# **Amendment Report**

## **Application for Licence Amendment**

Licence Number	L8103/1989/3
Licence Holder	Aragon Resources Pty Ltd
ACN	114 714 662
File Number	2013/001965-1
Premises	Fortnum Gold Mine
	Mining Tenements: M52/6, M52/95, M52/96, M52/98, M52/99, M52/132 and M52/133.
	MEEKATHARRA WA 664
	As defined in Attachment 1
Date of Report	30 October 2020
Decision	Revised licence granted

## Figure 2: TSA location and design

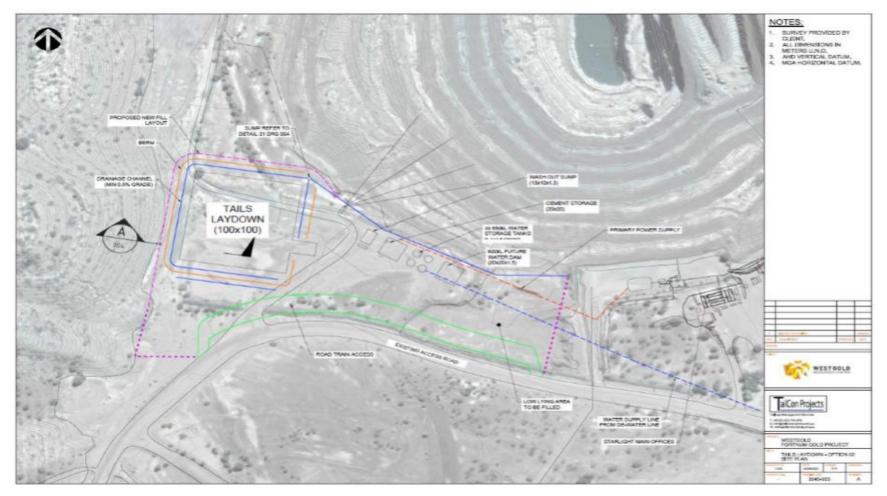
Condition or Amendment Report section	Summary of Licence Holder's comment	Department's response		
Licence Appendix 3 - Stockpile area design for paste plant and paste discharge location	<u>DWER request:</u> Please provide an updated drawing with grid coordinates and illustrate the paste discharge point location for Starlight underground mine <u>Licence Holder comment:</u> Appendix 3 map has been updated to include grid coordinates and illustrate the location of the paste discharge point.	Updated drawing with grid coordinates and paste discharge point location noted and added to Appendix 3 of the Licence		
Amendment report section 2.1.2 – application summary	<u>DWER request:</u> Please confirm the proposed capacity for Category 89 excluding the tonnage of tyres to be disposed of at Starlight and Toms in-pit TSF. <u>Licence Holder comment:</u> The proposed Capacity for Category 89 (excluding tonnage of tyres to be disposed of at Starlight and Toms) will be 300 tonnes	DWER has determined the proposed disposal of used tyres at Starlight pit and Toms in-pit TSF does not fit the description of prescribed premises. These particular activities are nonetheless regulated through <i>Part 6 of the Environmental</i> <i>Protection Regulations 1987</i> as noted in section 6 of this report. The proposed capacity for Category 89 (Callies and Yarlarweelor WRL landfills) has therefore been reduced from 500 tonnes per annum to 300 tonnes per annum. The Licence Holder is required to comply with landfill conditions 2 (a) to (d).

Amendment report section 2.1.3 – paste plant and mobile crusher infrastructure/equipment	<u>DWER request:</u> Please confirm the number of pumps for the drainage collection sump <u>Licence Holder comment:</u> Two pumps will be installed in the sump	Noted. Condition 8 requires the licence holder to submit an audit report to DWER to demonstrate compliance with infrastructure/equipment requirements for the Transfer Stockpile Area.		
Amendment report section 3.1.1, Table 2 - key emissions, potential pathways and proposed controls	<u>DWER request:</u> Please advise if the TSA sump will be lined <u>Licence Holder comment:</u>	Noted. The potential impact of leachate (generated at the TSA) on site soils is medium risk and acceptable subject to the licence conditions (Table 4). The licence

## Figure 3: Location of tyre disposal at Toms in-pit TSF

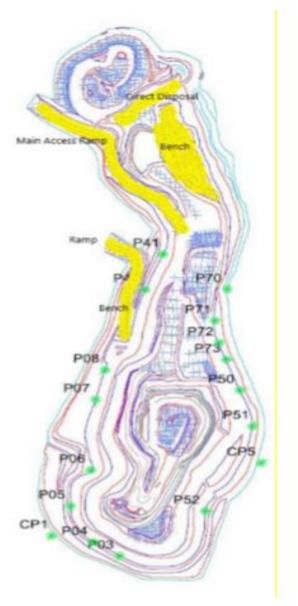
The Licence Holder additionally proposed disposing earthmover tyres directly into pit water – this particular activity is not supported as detailed in section 6 of this report.

The Licence Holder must not dispose used tyres directly into pit water at Toms in-pit TSF as proposed as this is not consistent with the requirements of *Part 6 of the Environmental Protection Regulations 1987.*
